LONG ISLAND LIGHTING COMPANY)

(Shoreham Nuclear Power Station,)
Unit 1))

SUPPLEMENTAL TESTIMONY OF DR. ROBERT N. ANDERSON,
PROFESSOR STANLEY CHRISTENSEN, G. DENNIS ELEY,
AND RICHARD B. HUBBARD
REGARDING SUFFOLK COUNTY'S EMERGENCY DIESEL
GENERATOR CONTENTION CONCERNING CYLINDER BLOCKS

SUFFOLK COUNTY
October 18, 1984

7396-244-26

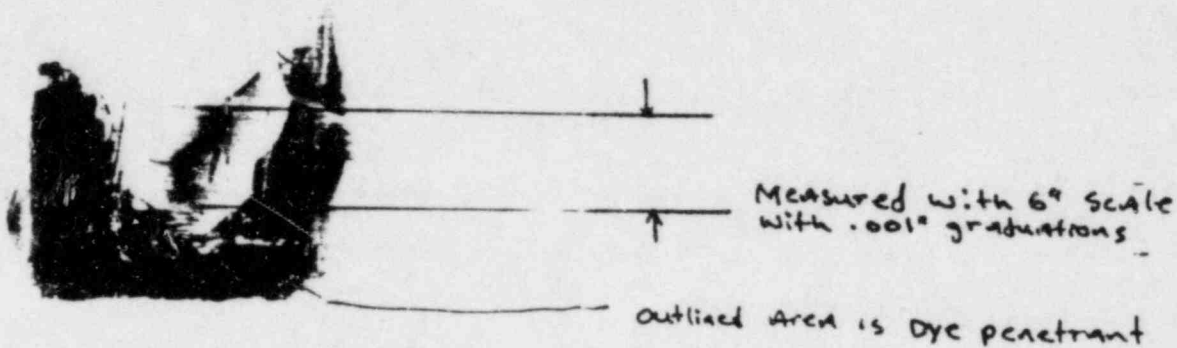
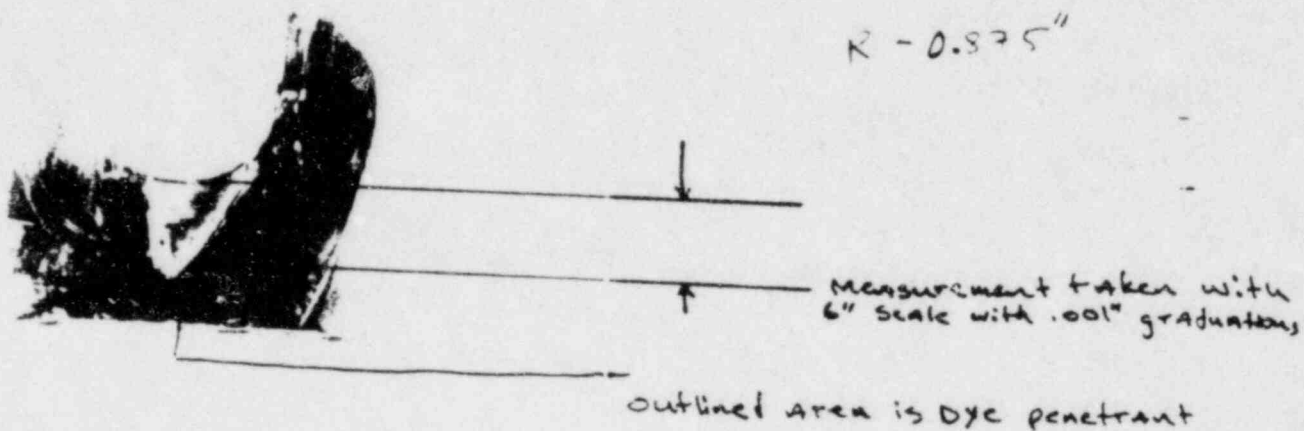
inches.^{2/} Some of these cracks were measured by FaAA after sectioning and found to be from 0.5 inch to 0.906 inch deep in a block wall only 1.25 inches thick.^{3/} FaAA found that all of these cracks had been ground and welded. Some representative photographs of these cracks are shown in Exhibit S-3.

^{3/} Exhibit S-2.

ORIGINAL BLOCK - EDG 103

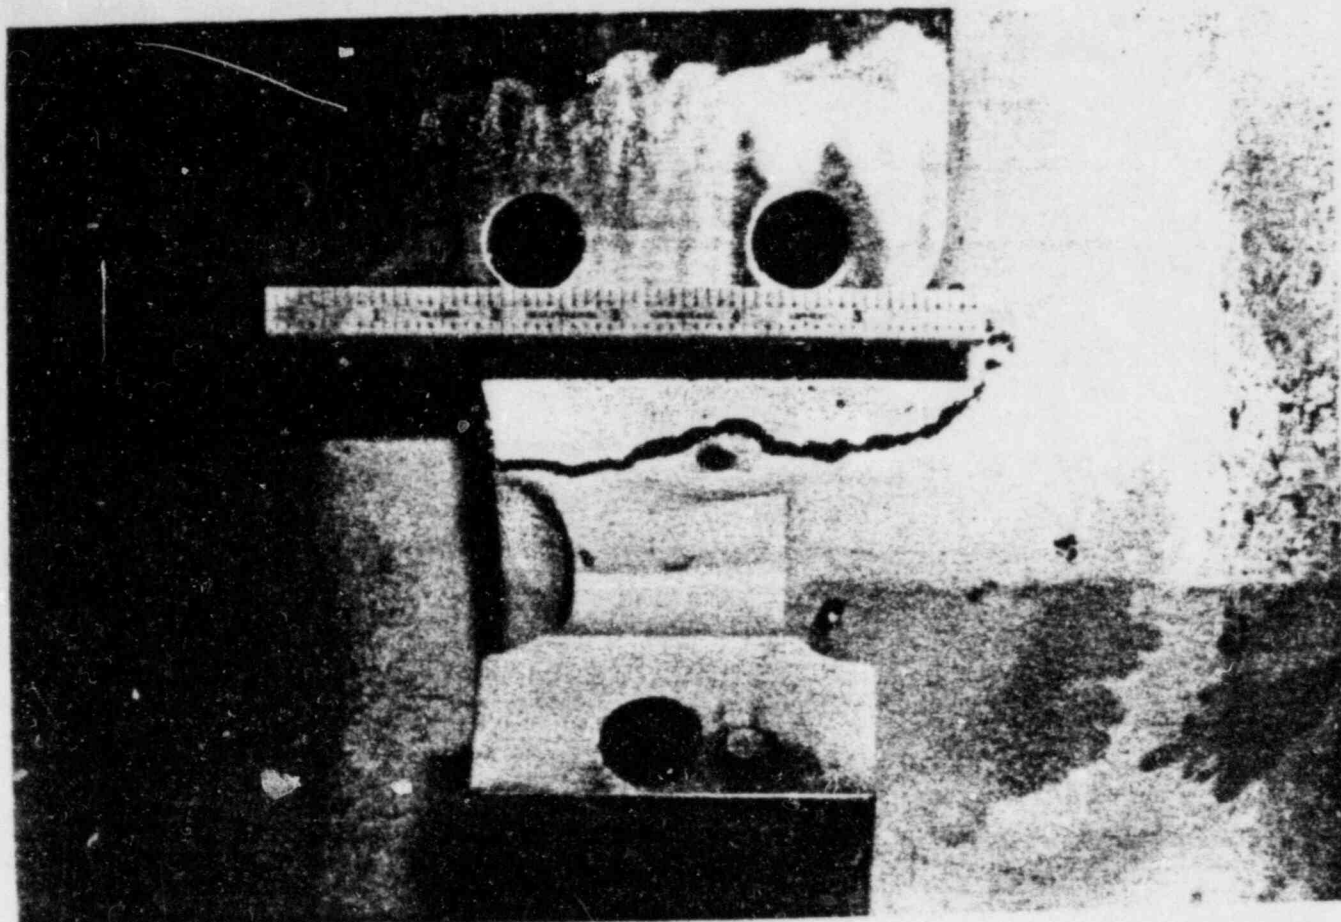
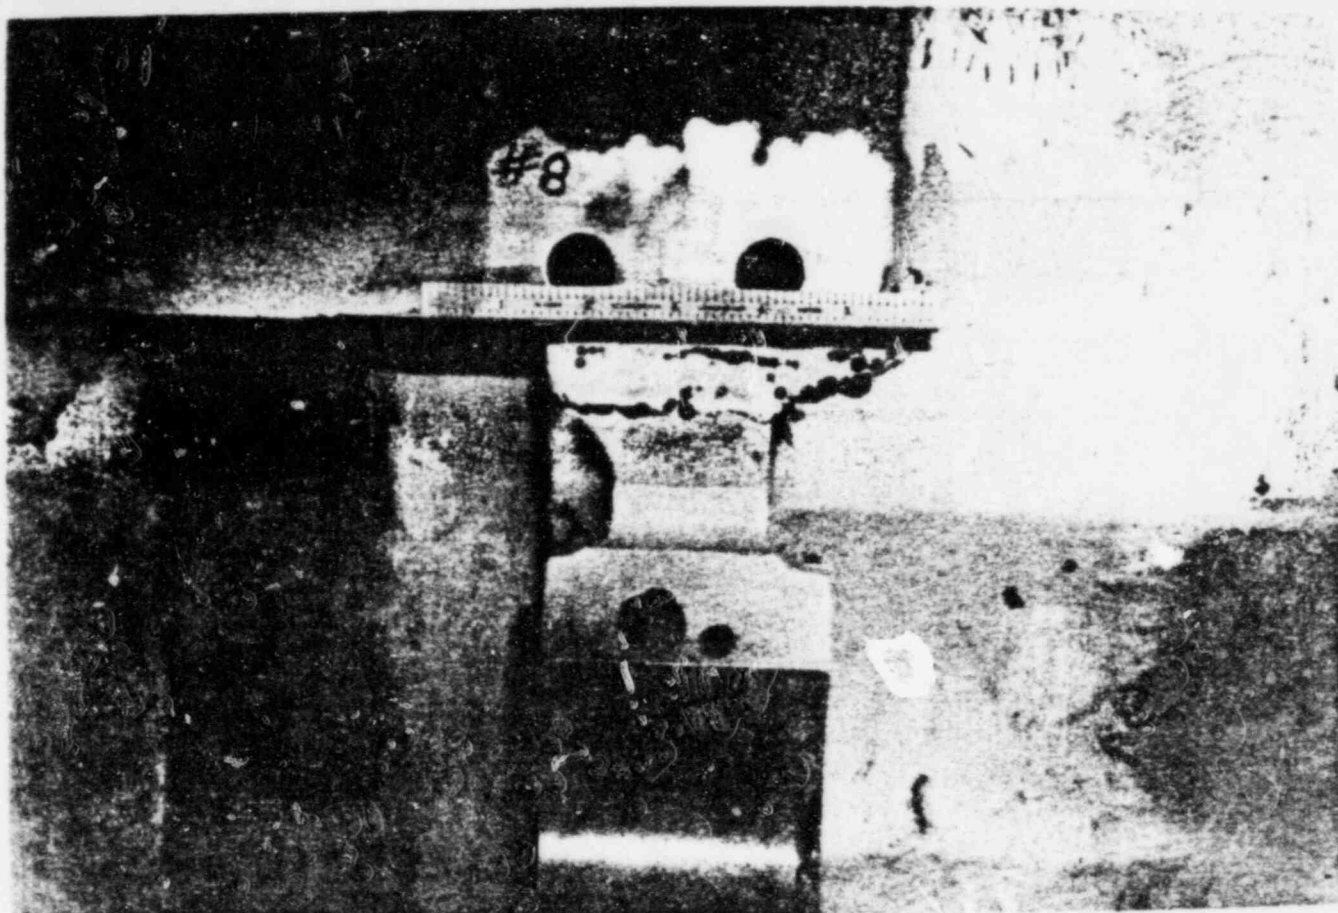
A. (Anderson). Based upon my examination of the sections removed by FaAA from the block and of numerous photographs of these cracks, they appear to be hot tears formed initially during fabrication of the block. This theory is supported by the fact that the cracks were filled with welding material in an apparent effort to repair them.

IR43* EDG 103
MT EXAMINATION INDICATIONS

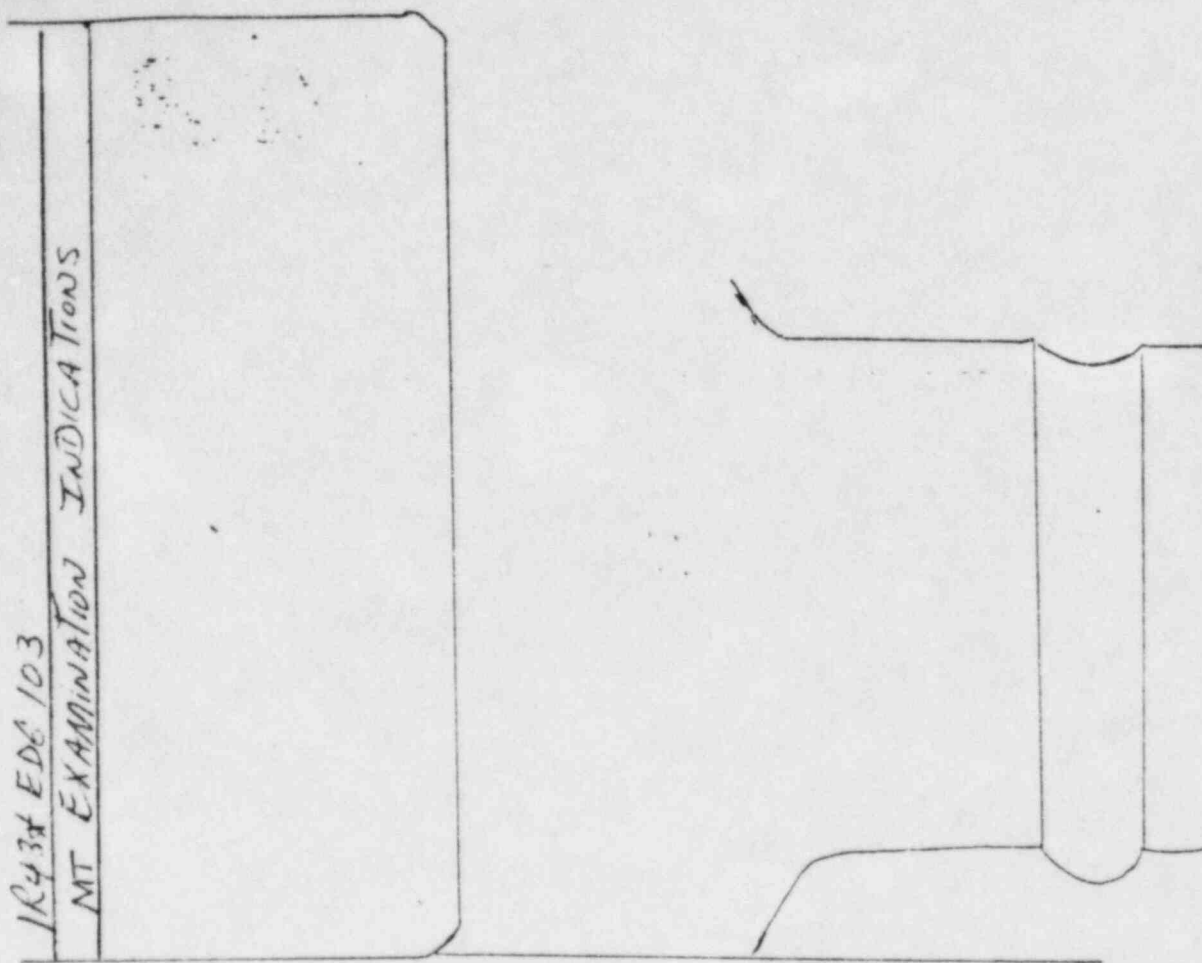
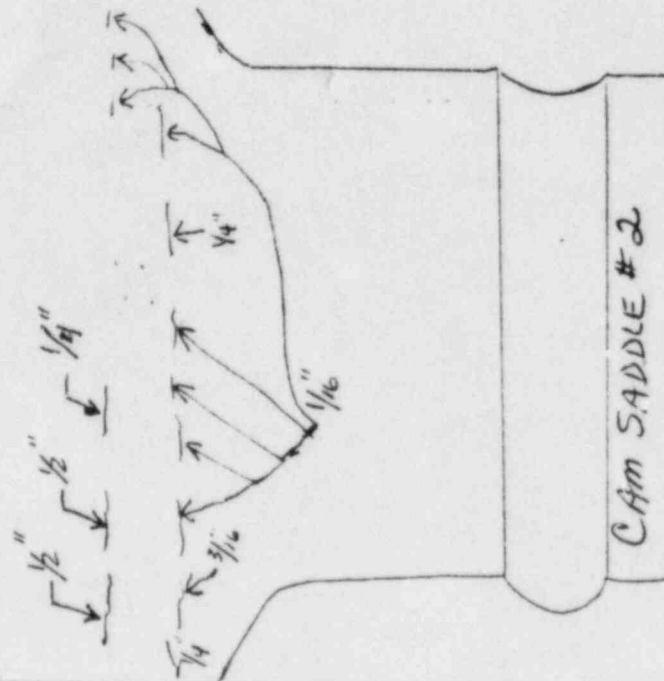
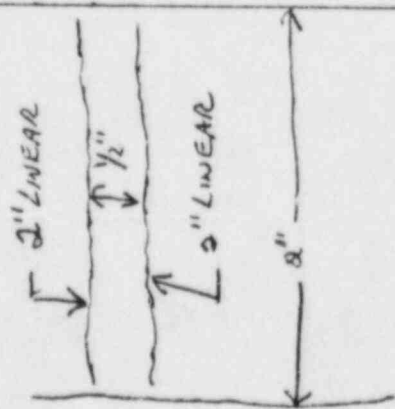
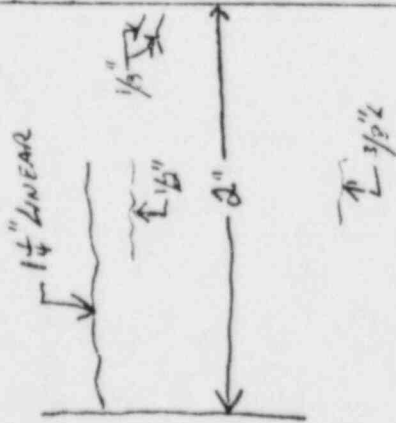
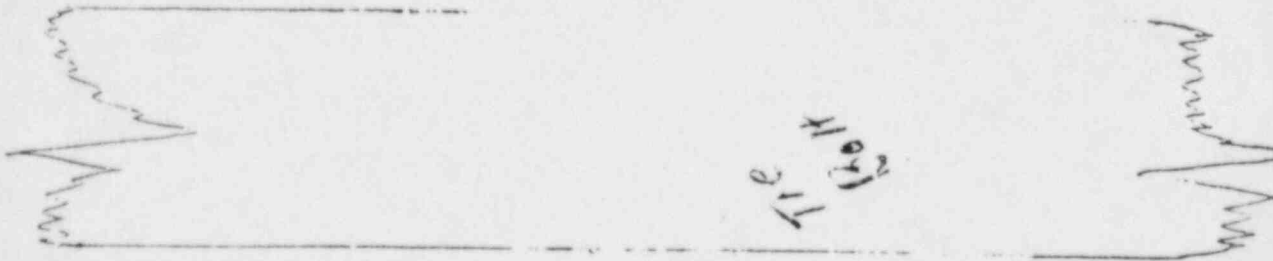
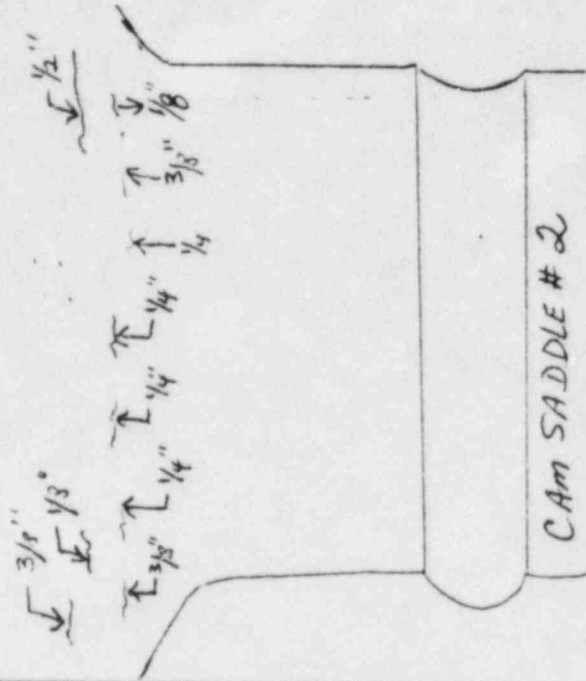
A. (Hubbard, Anderson). Yes. The areas of cam bearing saddles numbers 2 and 8 were inspected by LILCO both before and after grinding (on September 30 and October 1, 1984) while preparing EDG 103 for additional testing. The test reports show cracks in both of these areas, ranging up to 2 inches long.^{5/}

We therefore conclude that the cracks in the camshaft gallery area of the replacement block initiated, or propagated from sub-surface defects, during and as a result of the operation of EDG 103.

Figure 1-1. Location of cracks.

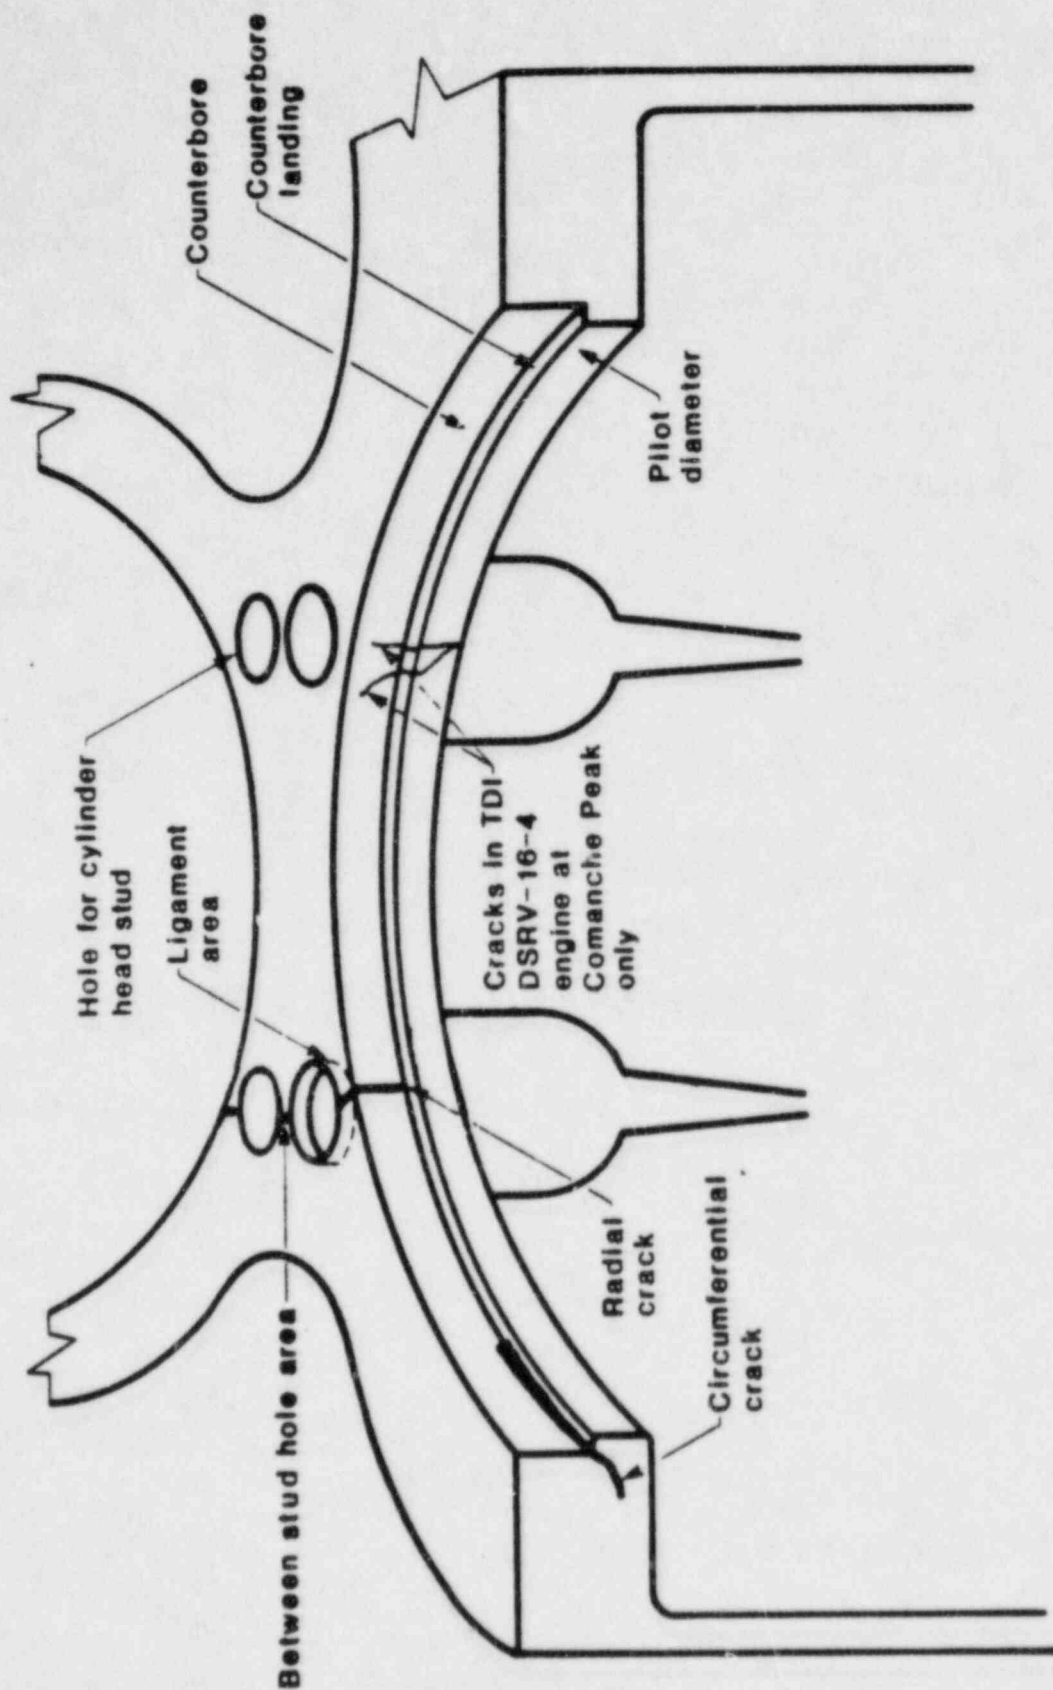
A. (Hubbard, Anderson). Yes. The FaAA Block Report erroneously stated that none of the EDG blocks had circumferential cracks. Circumferential cracks are cracks at the corner formed by the cylinder liner counterbore and the cylinder liner landing; a representational drawing of a circumferential crack is shown in

Exhibit S-9.^{7/} After August 14, FaAA found "some" circumferential cracks when it sectioned portions of two cylinders of the original EDG 103 block, according to LILCO's Supplemental Testimony. Actually, the LILCO report of magnetic particle inspections conducted on September 19, 1984^{8/} shows circumferential cracks extending 100 percent around the circumference of all eight cylinders.

^{7/} Exhibit S-9 is Figure 1-1 of the FaAA Block Report.
